SCHEDULE OF AMENDMENTS TO

THE DRAFT MONG KOK OUTLINE ZONING PLAN NO. S/K3/30 MADE BY THE TOWN PLANNING BOARD UNDER THE TOWN PLANNING ORDINANCE (Chapter 131)

Summary of Representations and Planning Department's Responses in respect of the Draft Mong Kok Outline Zoning Plan No. S/K3/31

Figure 2: Existing view from VP A, ridgeline largely not preserved

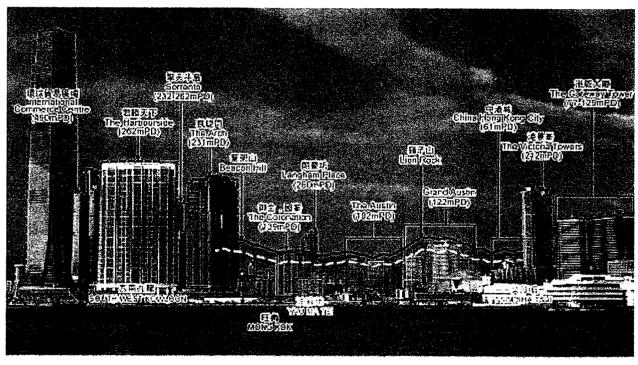
11.7 K3 Planning Area is located in inland area surrounded by fast growing coastal area with very tall developments. Is the consideration of ridgeline so important in the BH profile of K3 Planning Area? Figures 2 and 3 show the existing view from VP A (Sun Yat Sen Memorial Park) and VP B (Viewing Deck of Central Pier No. 7) on the Hong Kong Island. It can be seen that a significant part of K3 is screened by high rise buildings in the Southwest Kowloon and Tsim Sha Tsui. Also, many buildings are already intruding into the building-free zone or protruding the ridgeline.

Figure 4: View incorporated with BHRs on OZP No. 31 and committed developments from VP A

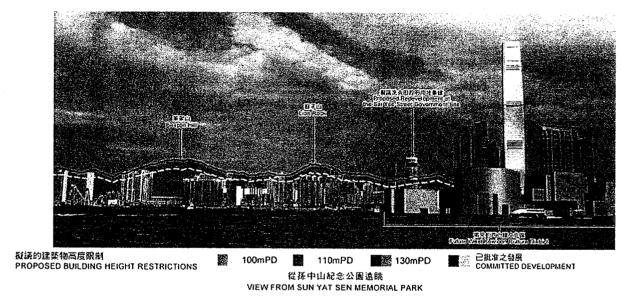
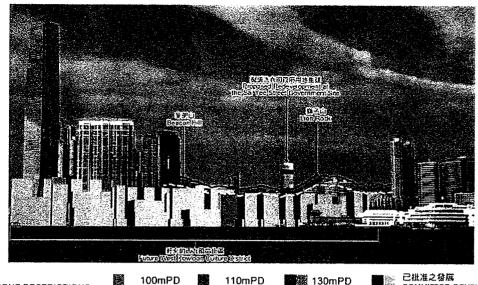
11.8 **Figures 4 and 5** are views which had incorporated buildings of the proposed BHRs and committed developments. It is apparent that the K3 Planning Area plays only an insignificant role impacting on the panoramic views. The relative more visible developments within K3 are the Langham Place and the proposed SYS development. From both VPs, the existing and committed developments nearly reach/breach the whole yellow line which is the boundary of the building free zone.

Figure 5A VPA-Sun Yat Sen Memorial Park

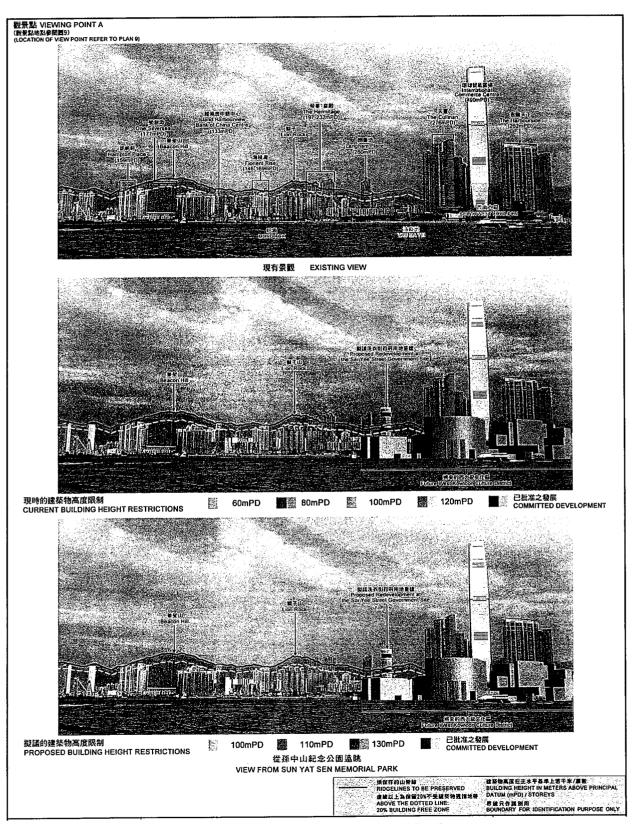
- 7.1.5 Effect on the public viewers Based on the above appraisal, the

perception of the public viewers on the panoramic townscape from this VP will unlikely be affected.

Figure 5B VP B – Viewing Deck of Central Pier No. 7

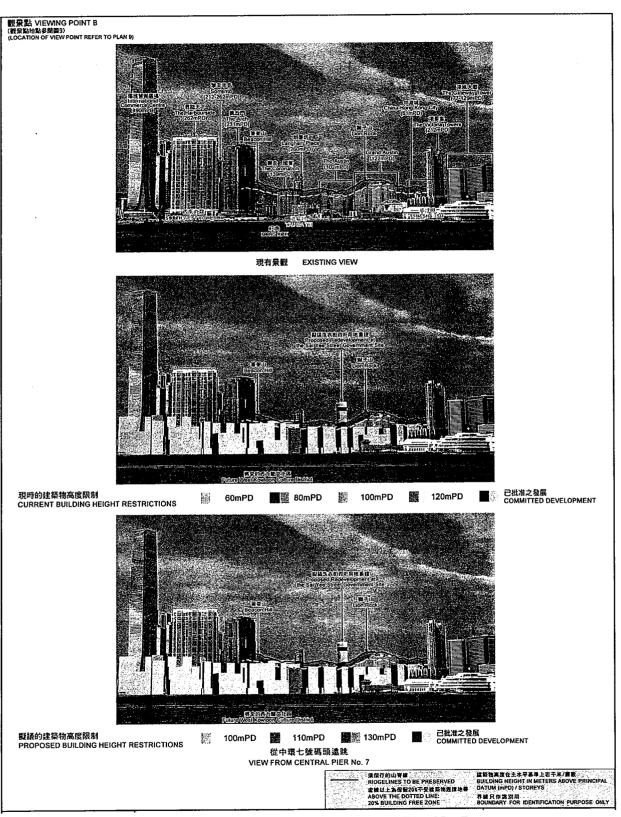
- 7.2.3 *Visual composition* The redevelopments under the relaxed BHRs will not be visible from this VP. The future development at the Sai Yee Street Site will add a new marker to the skyline of Kowloon Peninsula.
- 7.2.4 Visual obstruction and effect of visual resources Under the proposed BHRs, the resulting buildings would be shielded from view at this VP. While the future development at the Sai Yee Street Site would marginally block a section of the ridgeline, it would add visual interest as a distinctive marker to the panoramic view of the urban skyline.
- 7.2.5 *Effect on the public viewers* Based on the above appraisal, the perception of the public viewers on the panoramic townscape from this VP will unlikely be affected.
